**GOVERNMENT OF THE DISTRICT OF COLUMBIA
DEPARTMENT OF CONSUMER AND REGULATORY AFFAIRS
OFFICE OF THE ZONING ADMINISTRATOR**

Re: Waterfront Station PUD
4th and M Streets, S.W.

Board of Zoning Adjustment
District of Columbia
CASE NO.18615
EXHIBIT NO.45

W A T E R F R O N T W A S H I N G T O N , D . C .

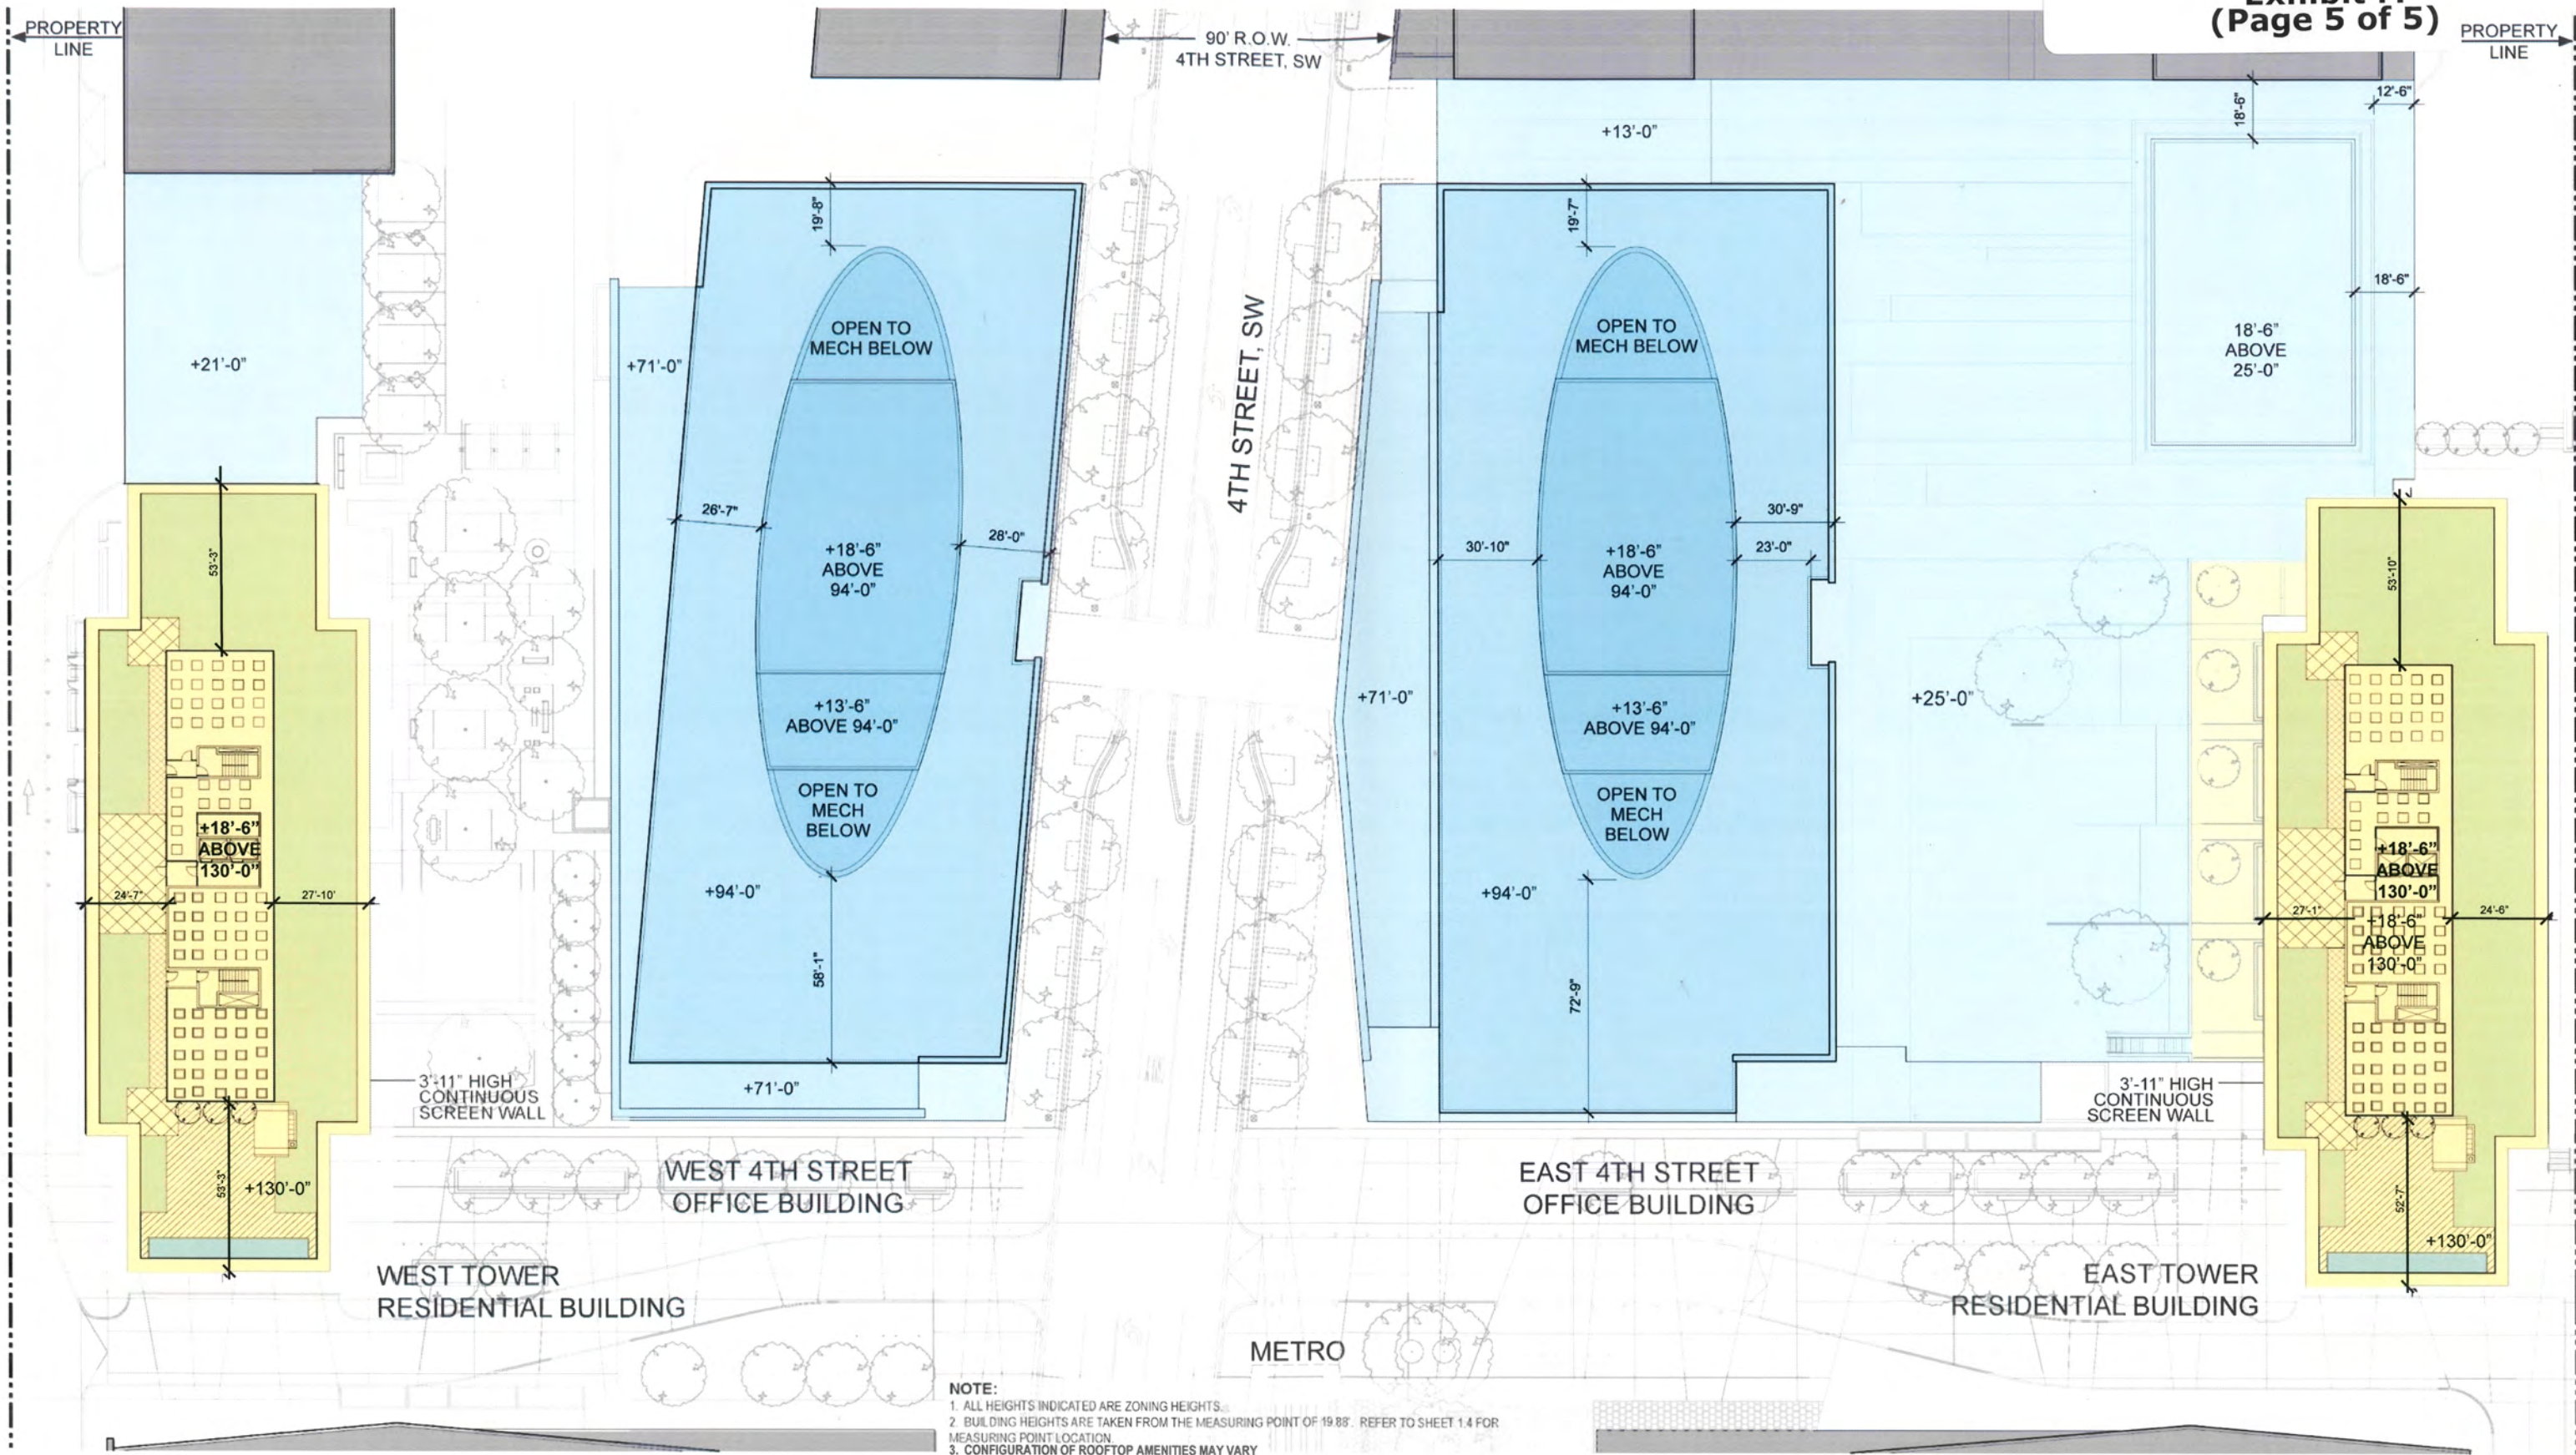
We compared the elevations of the four sides of the West Tower from the approved plans to the revised versions which you would like to construct. You propose to redistribute solid areas and glass areas, you propose to eliminate the cantilevered addition at the southeast corner of the existing building (an extension of approximately eight feet by fifty feet), you propose to replace recessed balconies with sliding doors and railings and to differentiate those portions of the buildings with a different color glazing and frames to maintain the vertical rhythm of the facades and you propose to add additional decorative guard rails in place of fritted glass panels. The effect of removing the cantilevered addition is to reduce the gross floor area by a small amount, but the change will be within two percent of the numbers set forth in the Order. The setback appearance of the elevation at the two story entry lobby will be maintained.

With respect to the roof, you propose to retain the size and location of the mechanical penthouse/equipment enclosure but would enhance the roof by bringing an elevator and stairs up through the penthouse to provide access for residents to the roof. You would add roof terraces and a pool, all of which would be setback at least 1:1 from the edge of the roof and would not exceed four feet above the roof. Those areas of the roof not occupied by the penthouse and not devoted to terraces would be devoted to a green roof.

The design as presented preserves the essential elements of the approved design, as set forth in the above-referenced findings. The integrity of the original design scheme is followed in your plans. The glazing, the metal clad horizontal and vertical bands which define the floor slabs and unit partitions and articulate the façade into three story increments and the modern architectural frames which wrap the midsection all reflect the description of the original design in Findings 62 and 63. The materials and colors choices will remain substantially similar to the original design. Even though the cantilever will be removed, that corner of the building will continue to be marked by a ten story vertical bay, as noted in Finding No. 63.

The decision to bring access to the roof and to activate the roof for use by the residents reflects what appears to be the Commission's desire, as set forth in Finding No. 64, even though the Commission indicated that it was satisfied with the previous architect's argument that doing so was infeasible. Your design for the roof, as described above, would comply with the normal requirements of the Zoning Regulations. The added elements would be below the screen wall and would not be visible from the ground.

My view is that the overall appearance of the Towers remains the same. The design for the East Tower will be essentially the mirror image of the plans for the West Tower. The design refinements are all consistent with the overall design scheme which was presented to and approved by the Zoning Commission.

It is therefore my conclusion that, if you present plans for a building permit which carry out the design shown on the plans dated September 27, 2010, for Sheets 2.8, 2.9, 4.3, 4.4, 4.5, 4.6 and 6.6, those plans would be consistent with the plans approved by the Zoning Commission and I would approve those plans for zoning purposes. Please let me know if you have any further questions.
